Line 3 Replacement Project LaSalle Creek Corrective Action Plan

**Enbridge Line 3 Replacement Project
LaSalle Creek Corrective Action Plan - Comment Response**

Technical Work Plan – Revision 2

To: Bobby Hahn, Enbridge, Kristin Lenz, Merjent
From: Ray W. Wuolo, PE, PG; Peter M. Demshar, PE, Kevin Eisen, PE, Travis A. Davidsavor, PE
Subject: Work Plan for Controlling and Sealing Groundwater Seepage – LaSalle Creek
Date: September 24, 2021

Figure 1 Completed Boring Locations

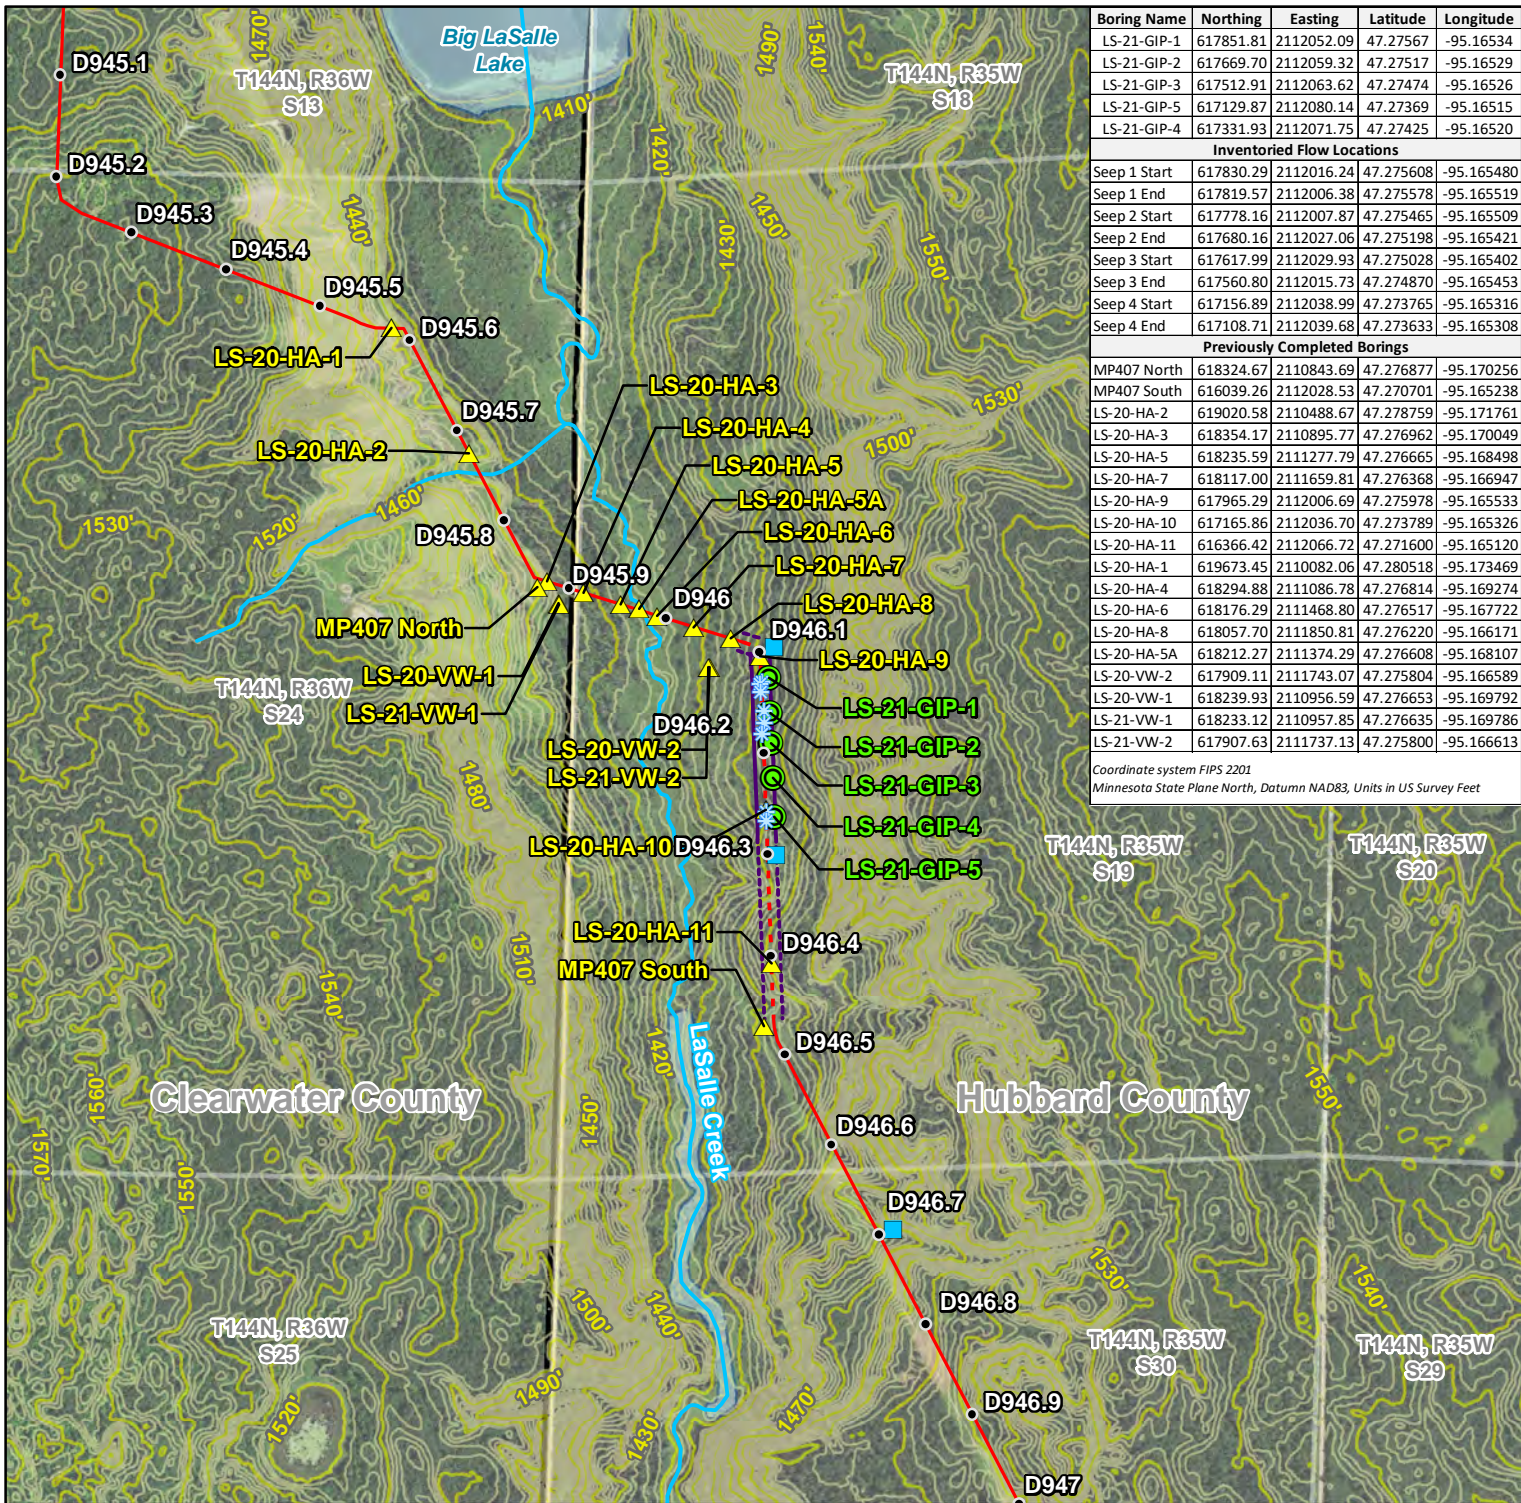
9	DNR Nathan Kestner	9/17/2021	The cross section in Figure 2 of the Barr September 14, 2021 GW Investigation Data submittal should be revised to include the water levels found in the borings and vibe wire piezometers. For example GIP2 has a hydraulic head of -12.5 ft (above land surface) 0.75 hours after drilling.	Figure 2 has been updated.
10	DNR Nathan Kestner	9/17/2021	Groundwater levels must be monitored for 2 additional years to ensure water levels stabilize. Provide a groundwater monitoring plan for approval. Commit to monthly water level data submittals-electronic spreadsheet format. The data should contain: a. An explanation of all abbreviations used including: Thead_Corr, Tip Elev etc. b. Dates of work construction events such as dewatering, sheet pile removal and construction (excavation and backfilling). For work over a time period, the date and time started and ended should be included. c. Pumping events with date/times started and ended along with flow rates and volumes. How the flow is measured should also be documented.	Enbridge is currently preparing a Groundwater Monitoring Plan which will be provided to the agencies for review by October 1, 2021.
